PARTS & SERVICE NEWS

REF NO. AT04184

SUBJECT: CANCELLATION OF FRONT COVER GASKET

APPLICATION: 102-1 Series Engine S/N 2620001 thru 26328958
102-2 Series Engine S/N 26271945 thru 26329022

2. Table of the modified parts (The Item No. given below corresponds to the Item No. indicted in the drawing.)

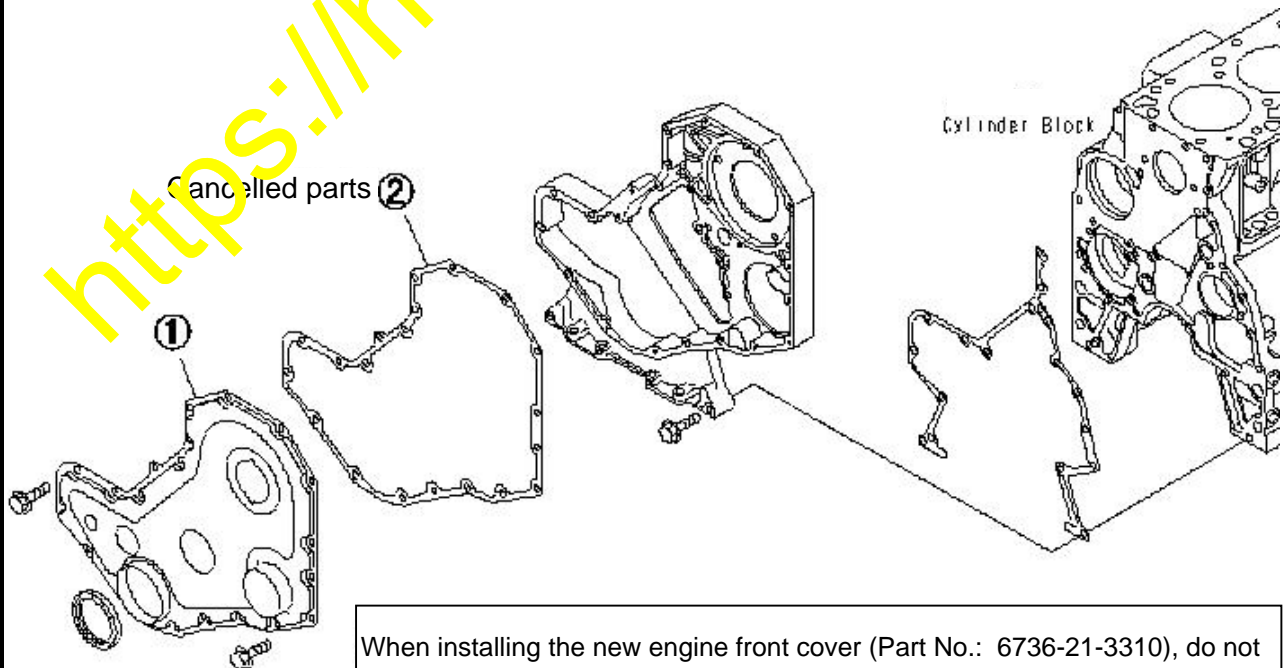
- (1) Modification of the front cover (<1>) --- (Rigidity against the liquid gasket has been increased.)
- (2) Cancellation of the front cover gasket (<2>) (Liquid gasket <- Sheet gasket)
- (3) Modification of other related parts (<3> and <4>). --- Refer to the next page and after.

However, the parts <3> and <4> may be applicable or inapplicable depending on the machine models on which the model of engine is mounted.

Redesigned shape of the cover

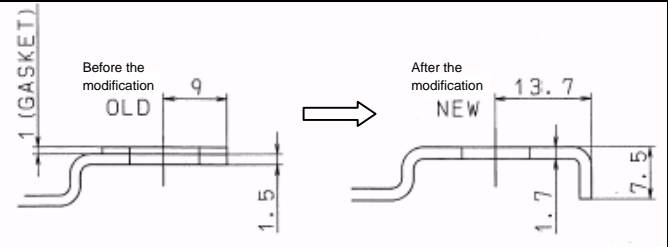
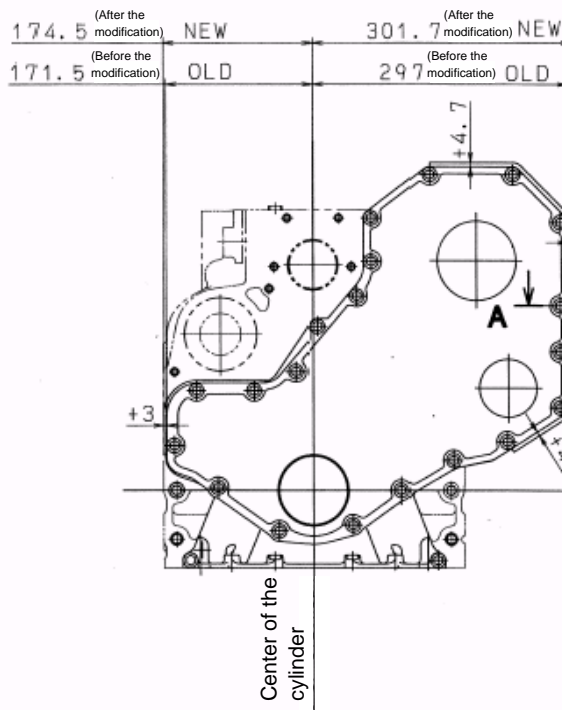
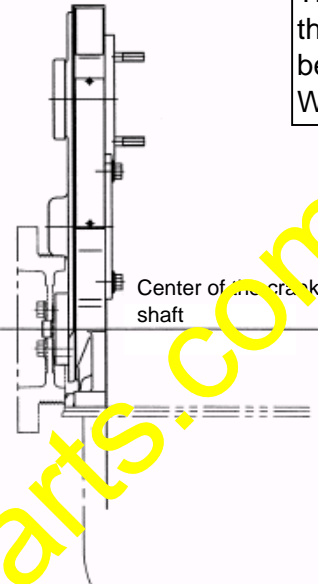
- (1) Modification of the front cover (<1>) and cancellation of the sheet gasket (<2>)

The plate thickness has been changed. With folded end

When installing the new engine front cover (Part No.: 6736-21-3310), do not use the current sheet gasket but apply liquid gasket (Three Bond TB1207C or the equivalent) to the mounting surface before installing it.

Modification of the bracket shape

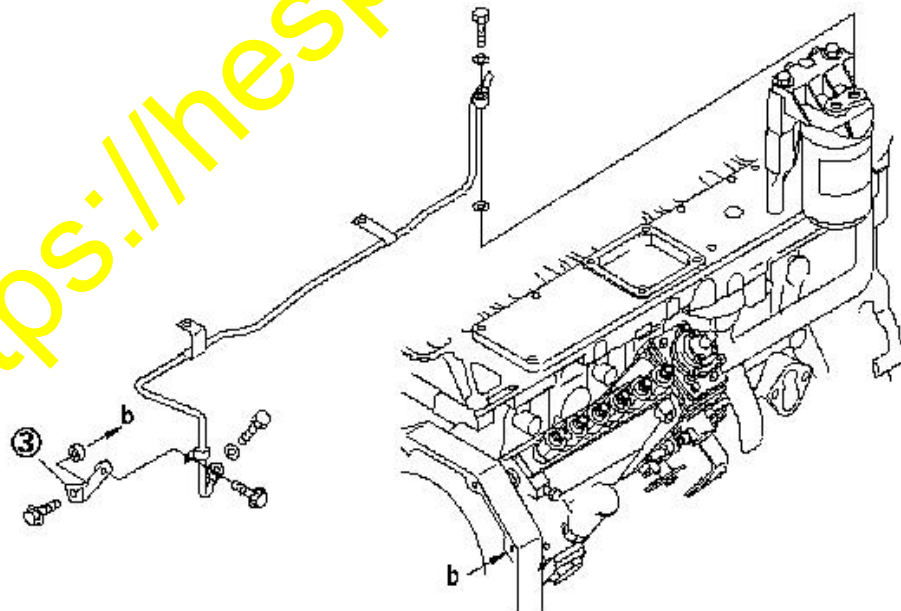
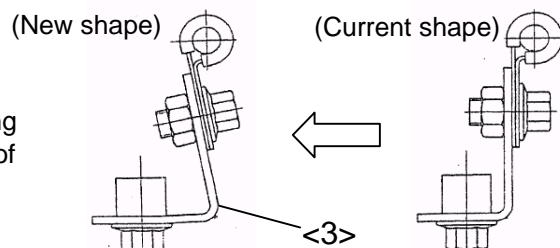
(2) Modification of the low pressure fuel piping clamp mounting bracket (<3>)

The shape of the bracket has been changed to prevent it from interfering with the folded section at the edge of the cover.

Consult the Parts Book for the machine models applicable to this modification.
